| Job Name: 36840 Red Berry Rd. Delmar, DE | Inspection Date: 1/23/2020 |

| Main Roof | Material: Shingles/Metal Roof | Roof Design:Hip Roof |

Below are images and descriptions of the issues caused by incorrectly installed shingles, siding, soffit and fascia.

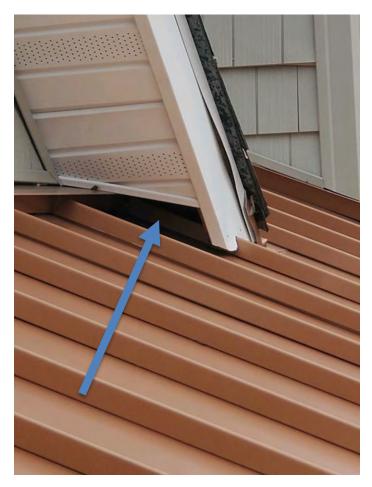
J-Channel needs to be tight to the metal roof to keep water and animals out. (done by others)

There is nothing wrong with how the metal meets the shingles. (Shingles were installed by others after metal roof was installed)

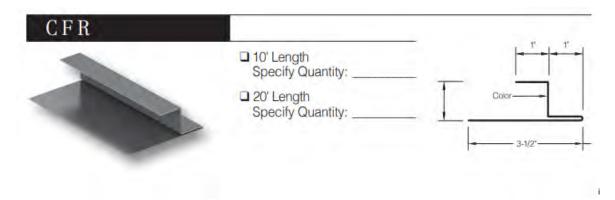
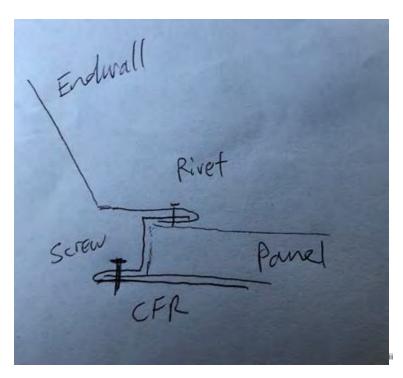
Soffit and J-Channel needs to be cut around metal roof to close gap. This is needed to keep water and animals out.(done by others)

J-Channel needs to be tight to the metal roof to keep water and animals out. (done by others)

VALLEY DETAIL

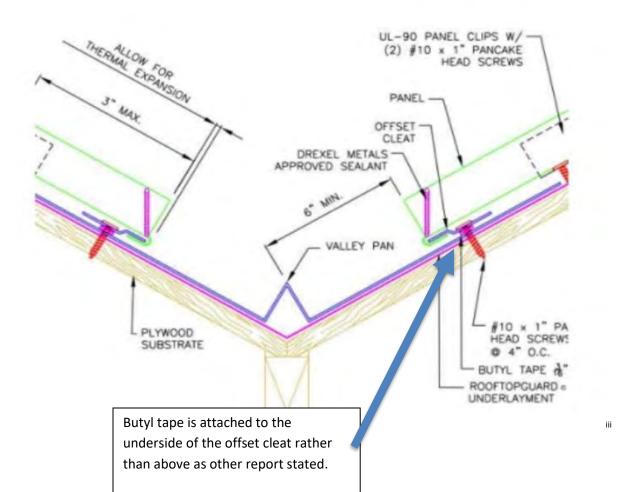
Additional Comments: Previous inspection report has incorrect information about the placement of butyl tape per manufactures instructions. The report has wrong information about the closures used where the metal roof meets the walls. Attached are drawing provided by Drexel Metals showing the CFR trim that was used per Drexel Metals specs and the placement of butyl tape in the valley detail. Bayside Exteriors is more than happy to work with any other contractor to help resolve these isses.
